**SUBJECT:** *CEMEX, Inc. (Florida Crushed Stone Company)  
Brooksville South Cement Plant; Brooksville, Florida  
Project No. 0530021-016-AC; Request for Additional Information*

CEMEX, Inc. (Florida Crushed Stone Company) is in receipt of the Department's Request for Additional Information (RAI) dated September 2, 2008, regarding the Brooksville South Cement Plant (Project No. 0530021-016-AC). The responses are listed below in the order as they appear in the letter.

Figure 2 - 3-hr Avg NOx vs TDF Feed Rate

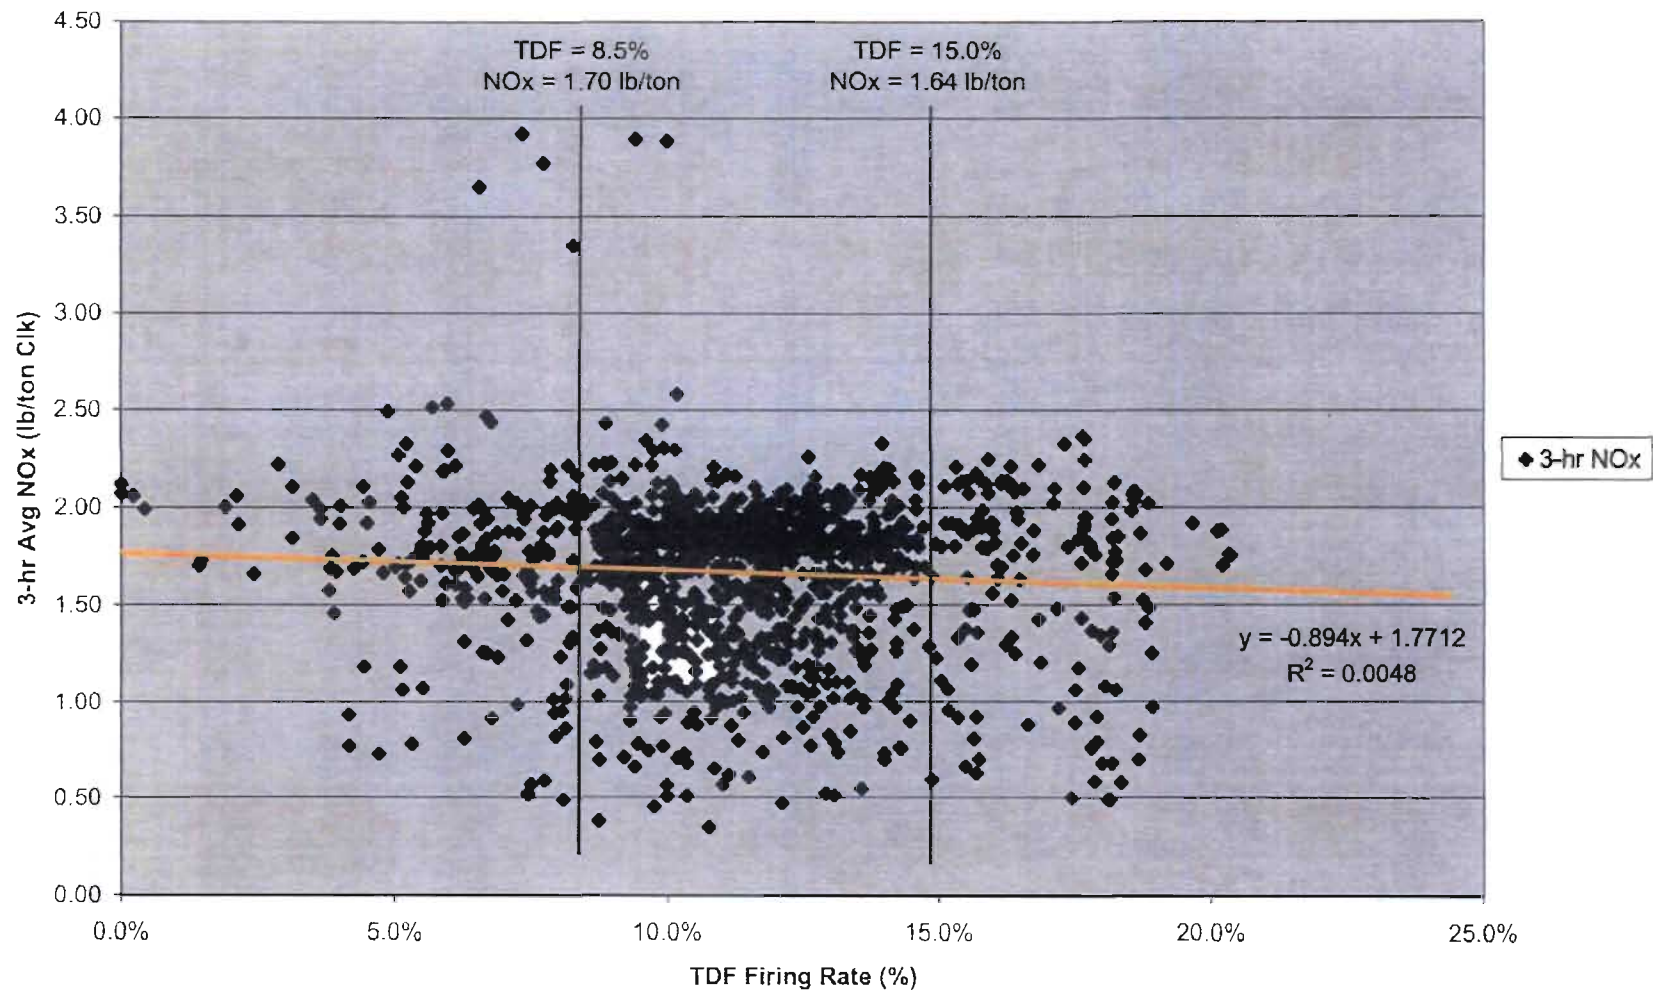
- 2. What is the historical heat input due to tire derived fuel? If the historical heat input is less than the permitted maximum firing rate of 15.0 percent of the total BTU heat input, conduct a Baseline Actual-to-Projected Actual Applicability Test for Modifications at Existing Emissions Units according to Rule 62-212.400(2)(a)1,**

**Florida Administrative Code (F.A.C.) in order to determine Prevention of Significant Deterioration applicability.**

CEMS data from Kiln No. 2 at the CEMEX Brooksville (North) facility was evaluated at varying heat input rates for tires. As shown in Figures 1, 2, and 3, the CO and NOx emissions were plotted versus the tire rates (as percent of total heat input rate to the kiln). Although the CO and NOx emissions data varies greatly, a slight correlation between the tire feed rate and CO and NOx emissions can be seen. In Figure 1, CO emissions increase somewhat as the tire feed rates increase, specifically the correlation plot shows an increase in CO emissions of approximately 24% when increasing the tire feed rate from 8.5% to 15%. In Figures 2 and 3, NOx emissions decreased slightly, specifically the correlation plot shows a decrease in NOx emissions of approximately 4% when increasing the tire feed rate from 8.5% to 15%.

As shown in Figures 2 and 3, NO<sub>x</sub> emissions may decrease slightly. To be conservative, baseline actual NO<sub>x</sub> emissions were set equal to future actual NO<sub>x</sub> emissions.
